Project Name: Willow - Bid Package 2 – New Build

Project No.: 221125-090

Architect: Kingscott

This Addendum is issued to inform the bidders of modifications in the scope of work being bid for this project.

COLOR LAYOUT PLAN - UNIT 100

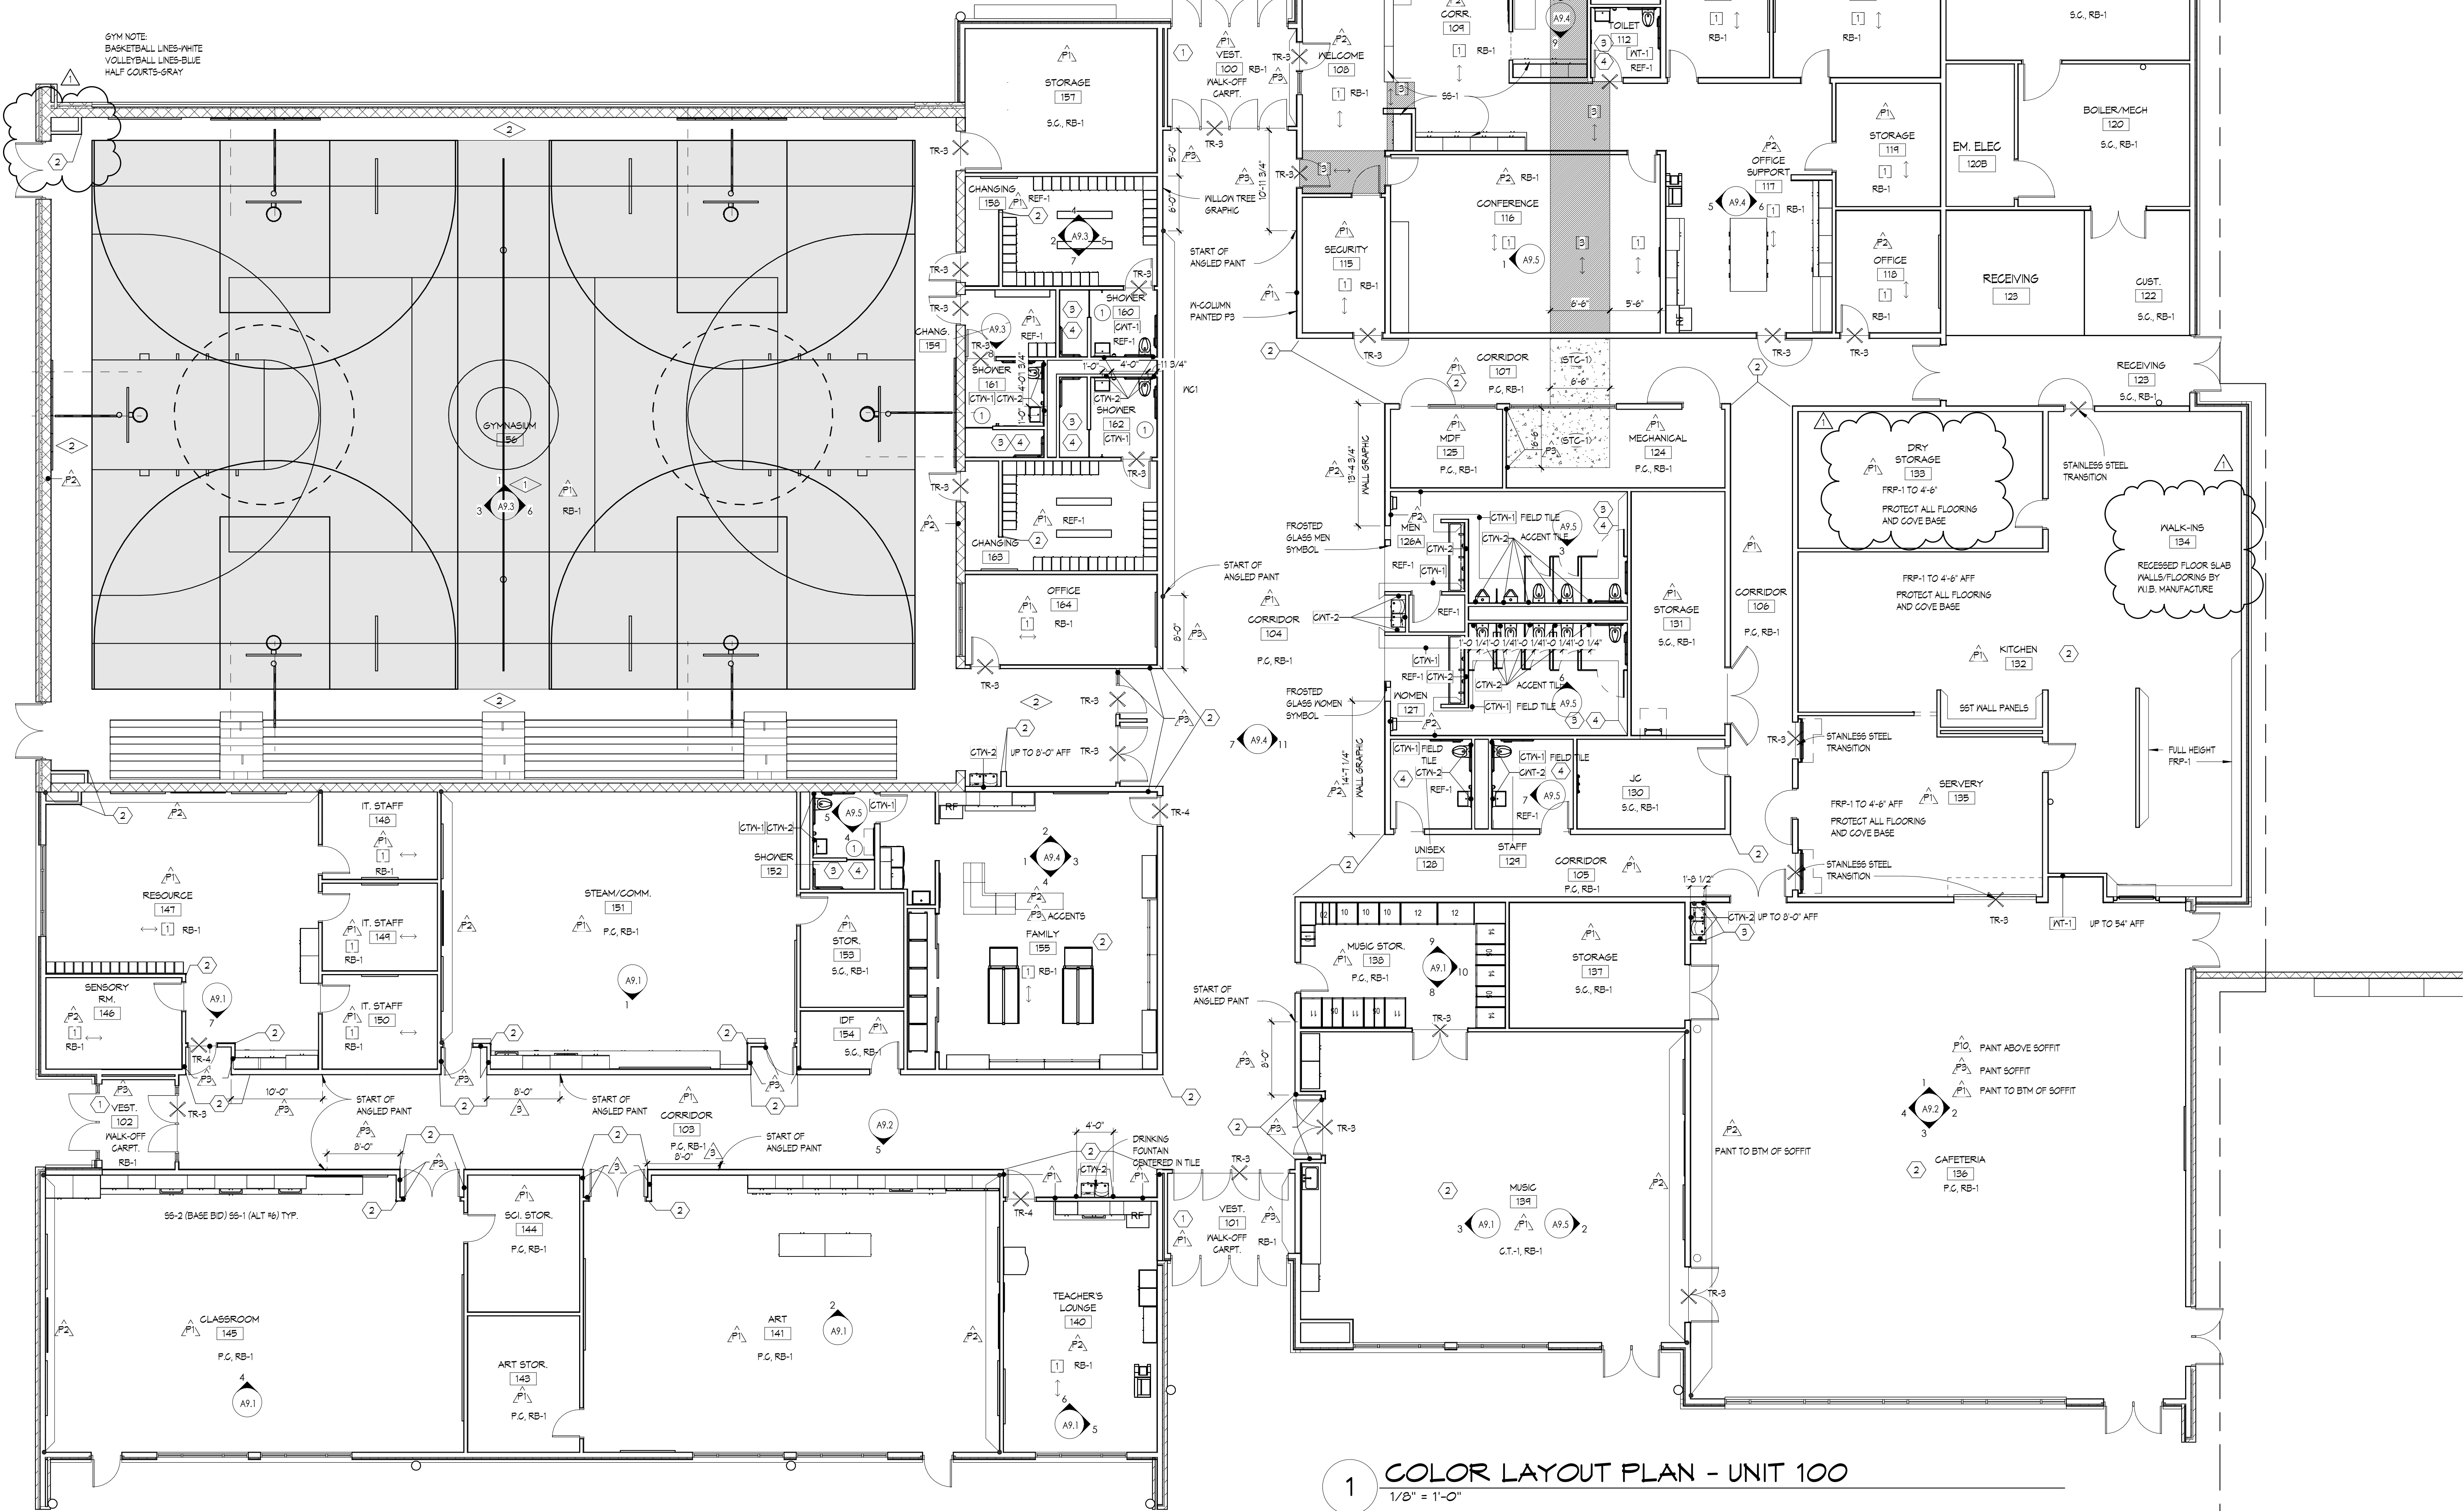
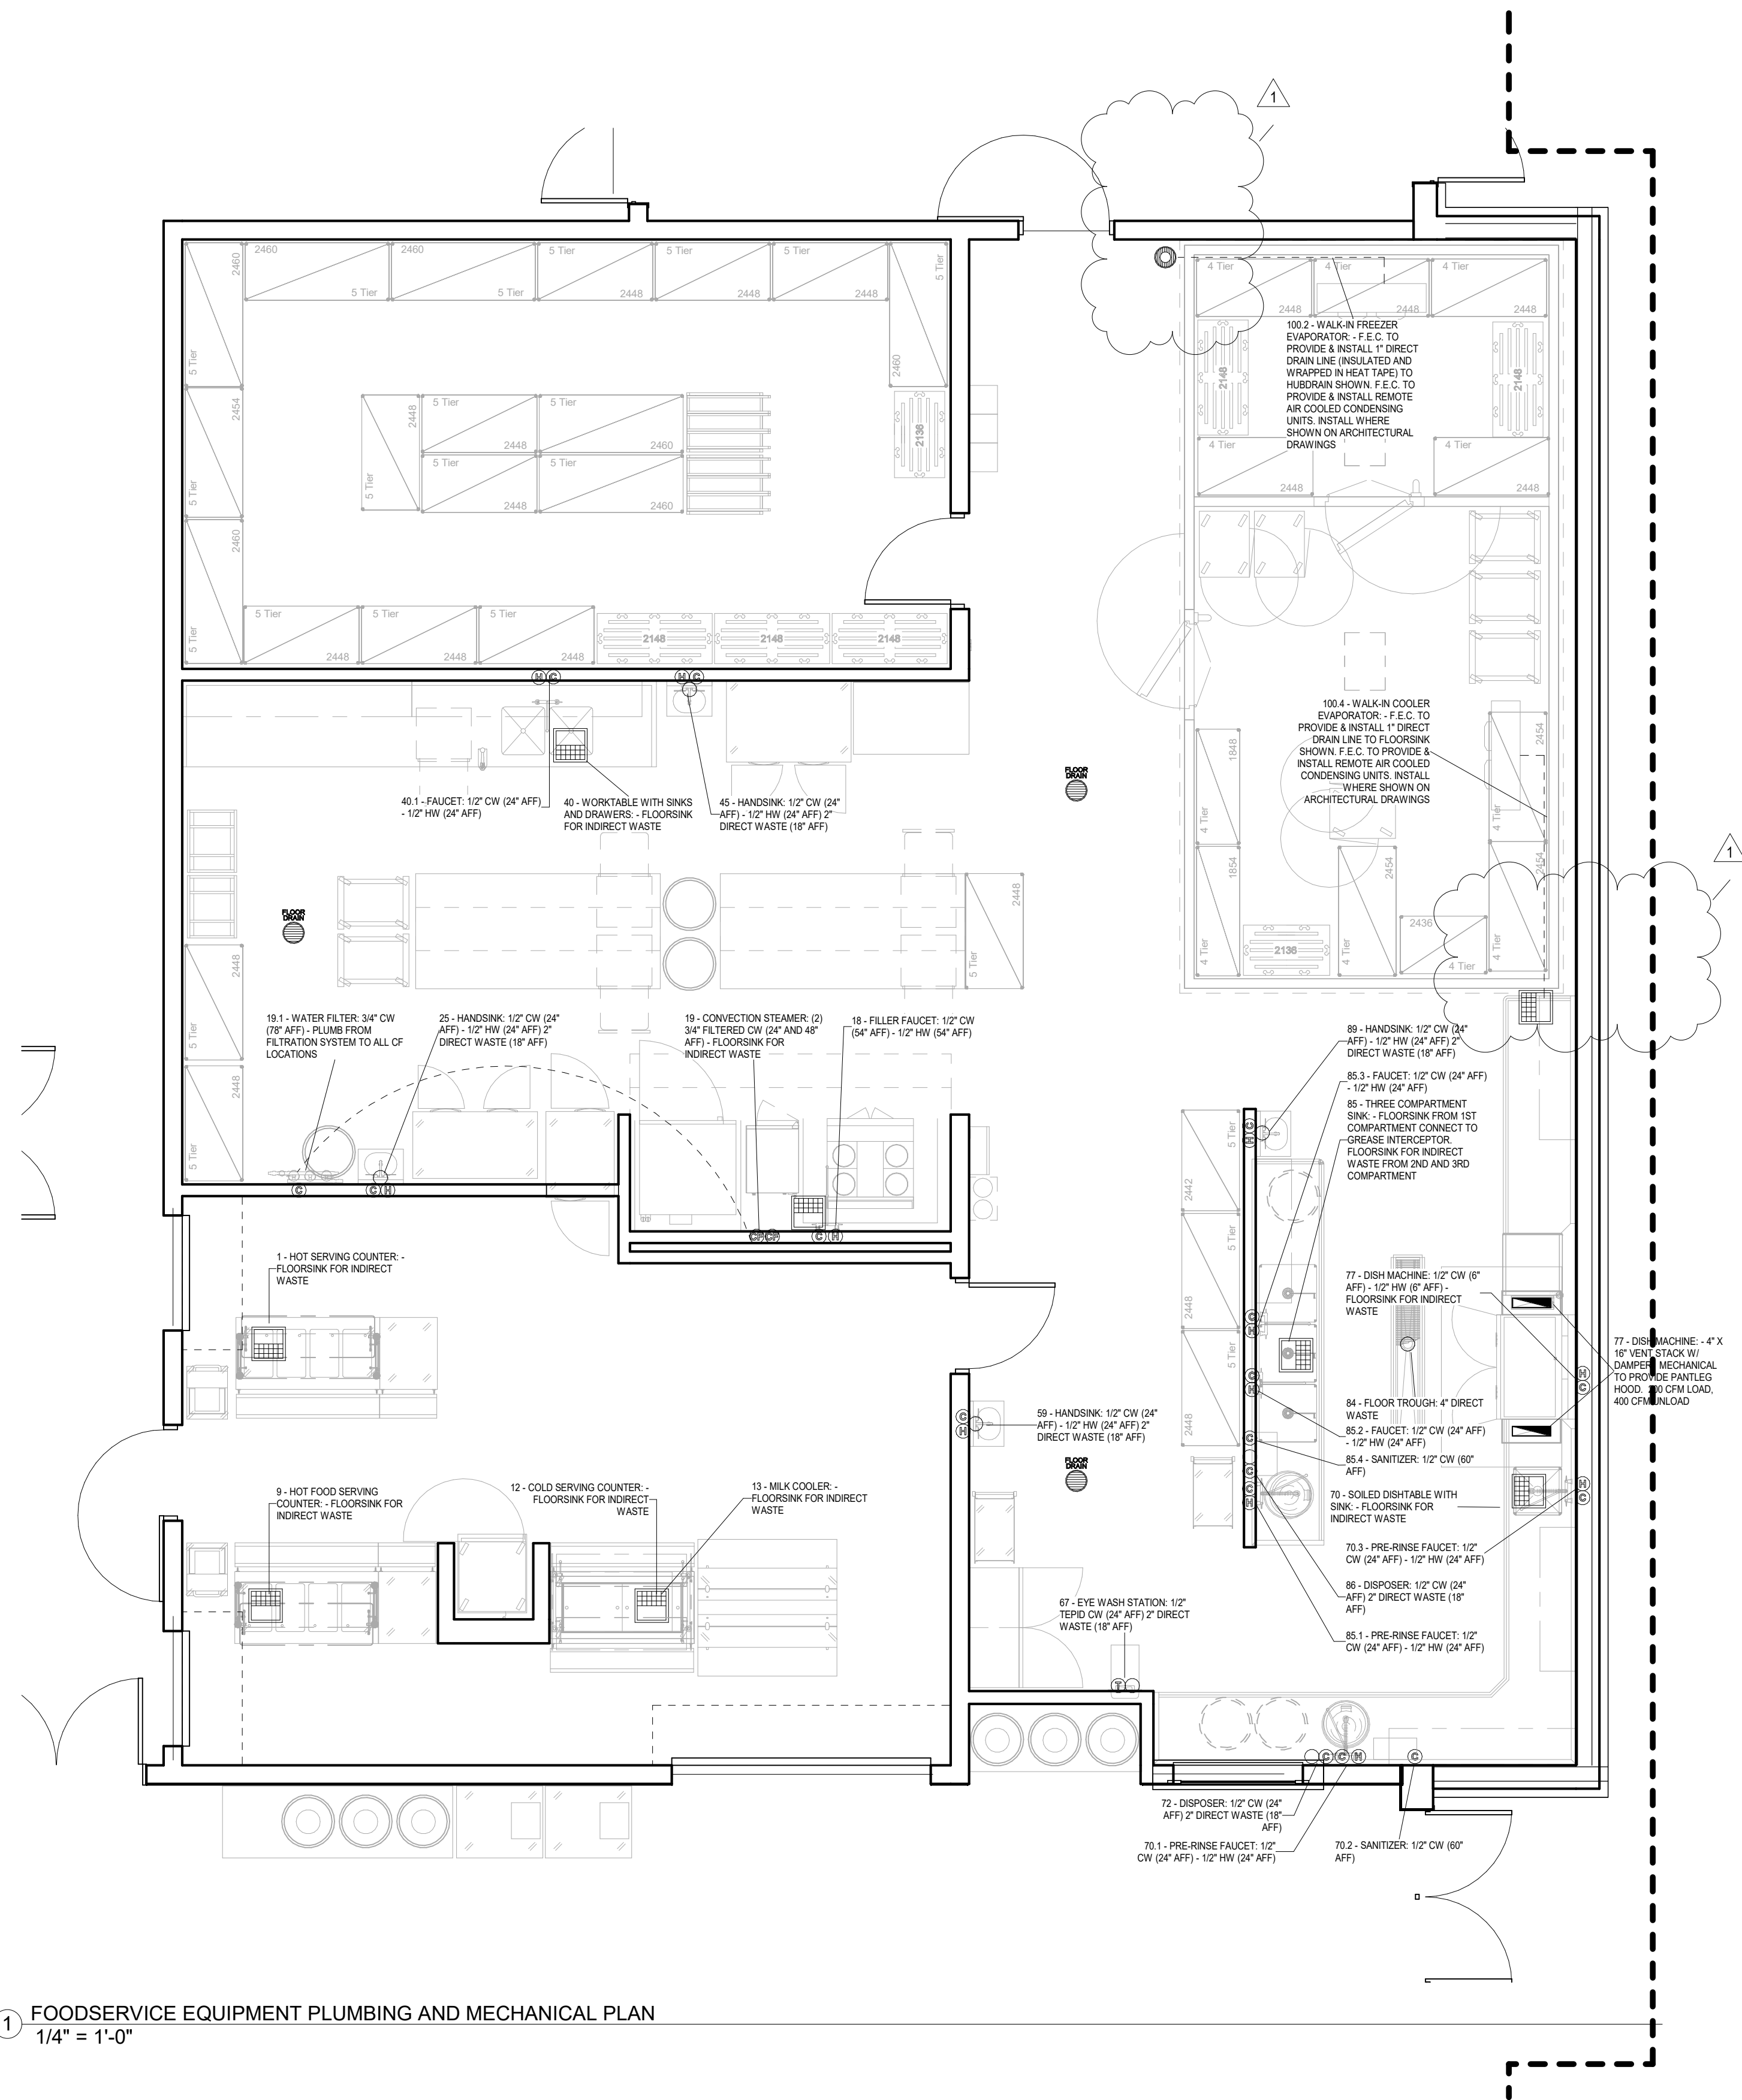
- Modified FRP-1 height in Dry Storage.
